Relicensing Study 3.3.3

Evaluate Downstream Passage of Juvenile American Shad

ADDENDUM 1

Northfield Mountain Pumped Storage Project (No. 2485)
and Turners Falls Hydroelectric Project (No. 1889)

Figure 1: Rates of Movement (RM/hr) for juvenile shad moving throughout the Turners Falls Impoundment and the canal with associated standard error.

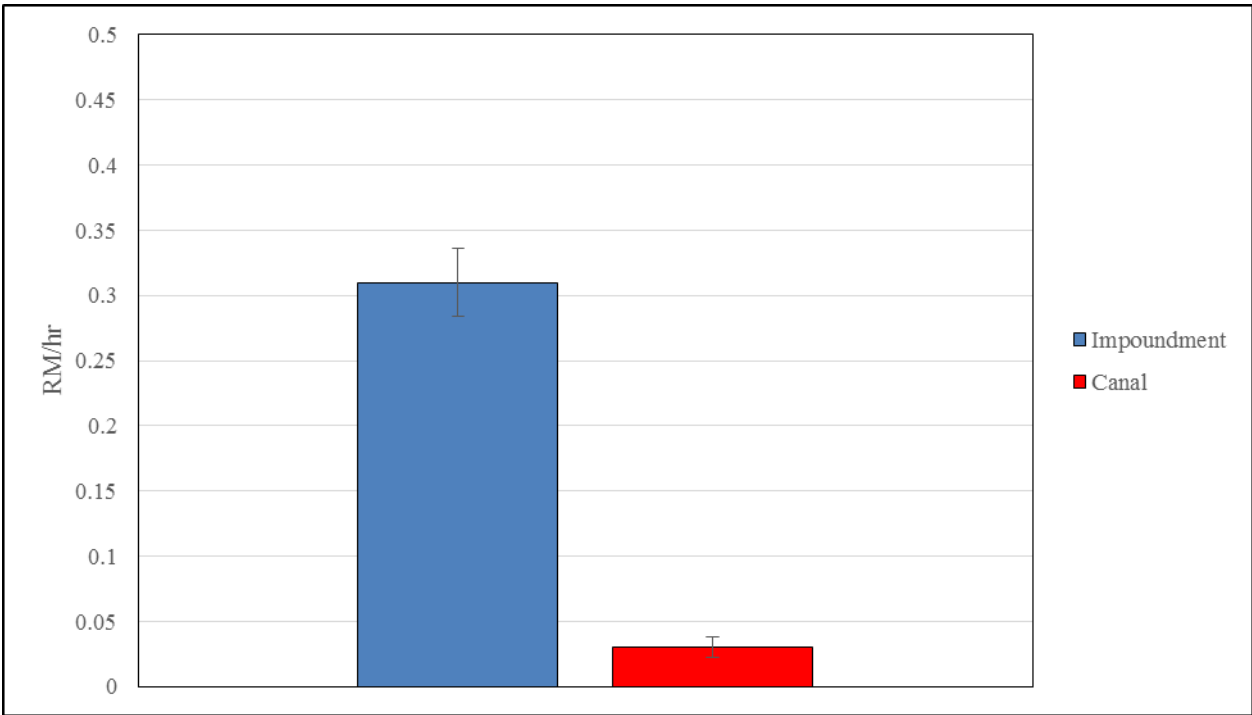
Section 5.2 Rate of Downstream Movement within the Impoundment, over the Dam and through the Bypass Reach, or through the Power Canal

“As is reported, very few fish were available for this analysis. We recommend the report state the amount of error associated with the various rates of movement.”

Rates of movement were calculated for juvenile shad moving through the Turners Falls Impoundment (TFI), the power canal and the bypass reach. The mean rate of movement within the TFI was 0.31 RM/hr with a standard error of 0.02. This calculation was based on the movement of the 113 fish detected in the TFI. The mean rate of movement within the power canal was 0.03 RM/hr with a standard error of 0.008. This calculation was based on the movement of the 4 fish detected within the power canal. These rates of movement are depicted in [Figure 1](#), depicted with their associated standard error values.
